2ND & Bell

2234 2nd Ave, Seattle

ARC Briefing Meeting 5

Oct 19th, 2020

ARC MEETING #1 SUMMARY & BOARD COMMENTS - APRIL 14TH, 2017

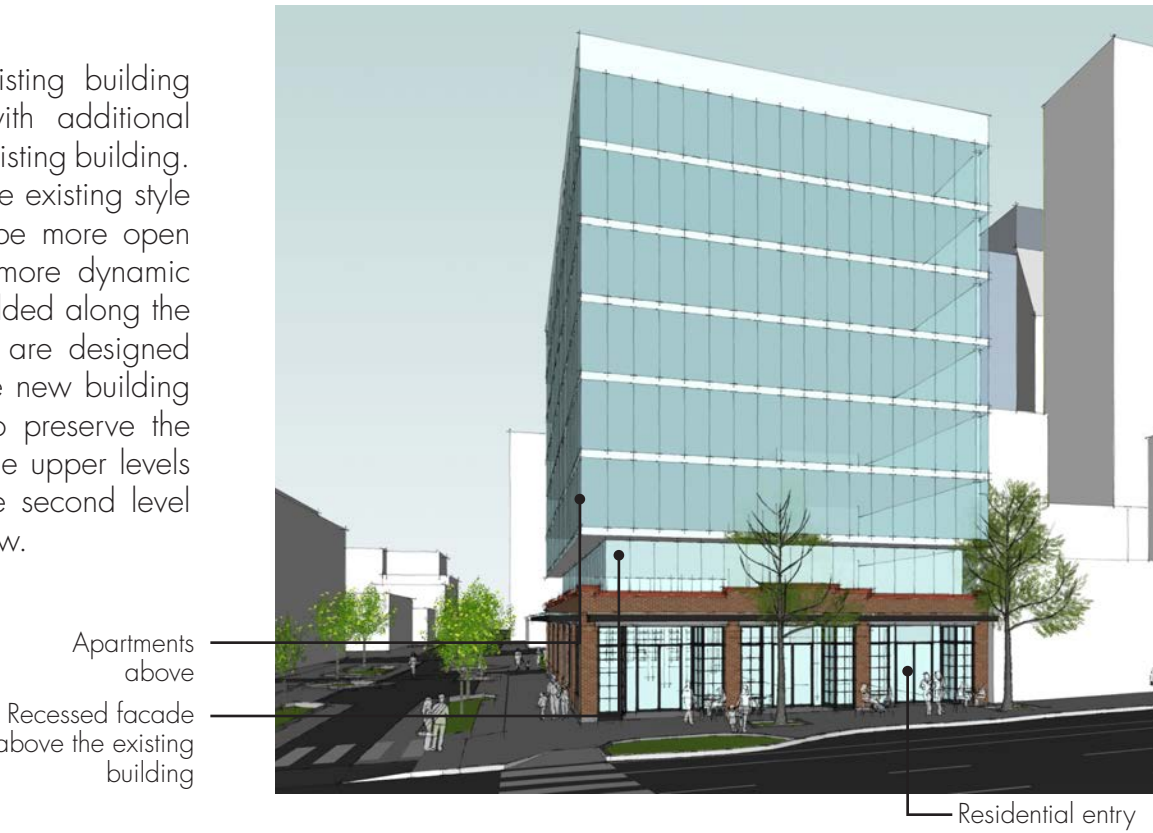
- 1. Recess at second level needs to be larger.
- 2. Board suggests not adding canopies to existing building.
- 3. Restore the Building to the original design as much as possible.
- 4. Explore way to make the existing building not dominated by the upper massing.
- 5. Refer to Secretary of the Interior's Standards as design guidance.

- Preserve and restore the existing building facade to the original state
- Incorporate a simple, recessed, small-scale hyphen to physically separate the old and the new volumes (Option A, B, C)
- Set the addition back from the wall places of the building below to separate the old and the new volumes (Option D)
- The new addition includes simplified architectural features that reflect the architectural language on the historical existing building: rhythm and alignment
- Use simple forms to differentiate and maintain the primacy of the historic building.
- Preserve the pedestrian level experience with the historic building

ARC MEETING #2 SUMMARY & BOARD COMMENTS - JULY 12TH, 2017

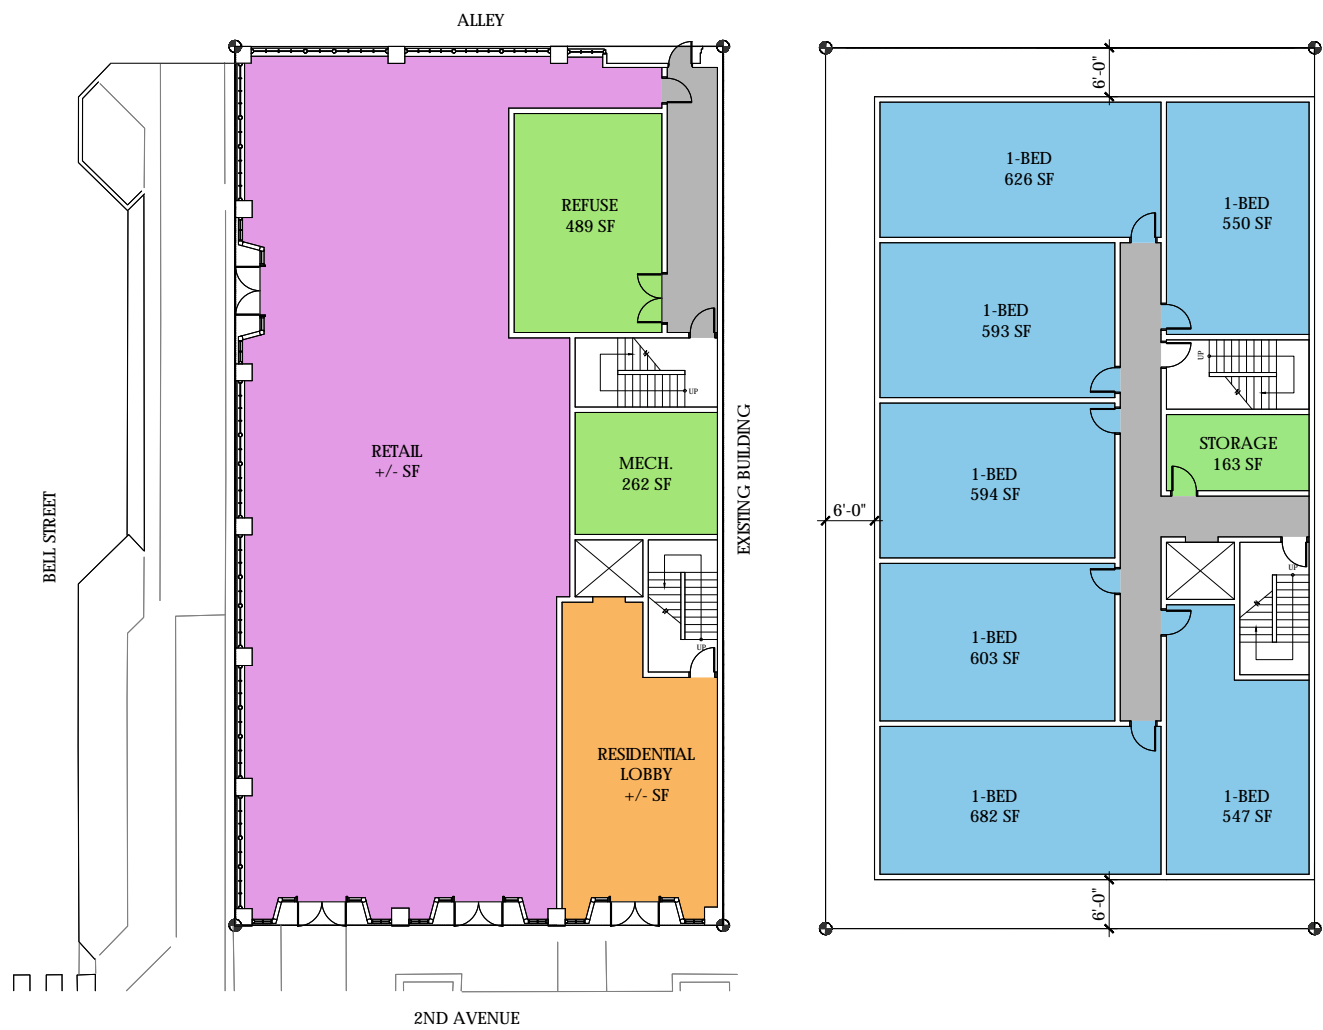
- The Board was in support of the Glass Option as it offered an opportunity for the addition to juxtapose the Landmark structure and to have the perception of being light to allow the Landmark to remain distinctive

ARC MEETING #4 SUMMARY & BOARD COMMENTS - APRIL 26TH, 2019

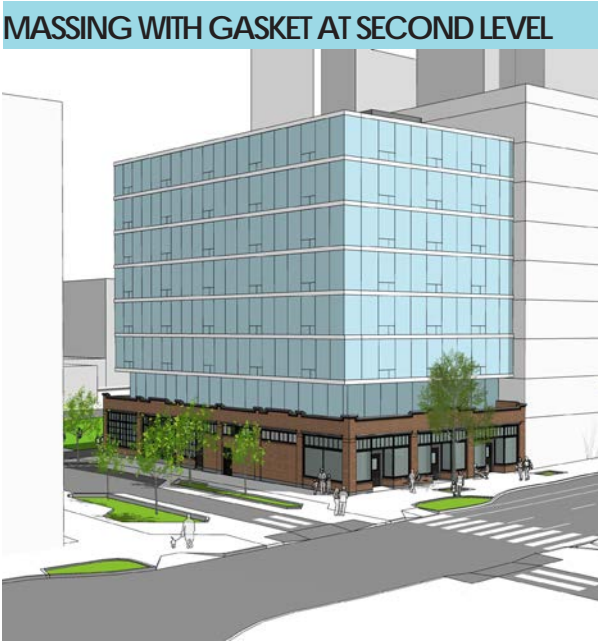
- Board supports scheme 2 presented in the meeting, with recessed top floor and roof overhang.
- Would encourage the design team to find ways to make window patterns above respond to the landmark building below.
- Board is okay with the minimal setback along alley as well as Bell Street but would like to see more setback on 2nd Ave.
- Would like to see the facade in the next meeting, and how the different parts work together.
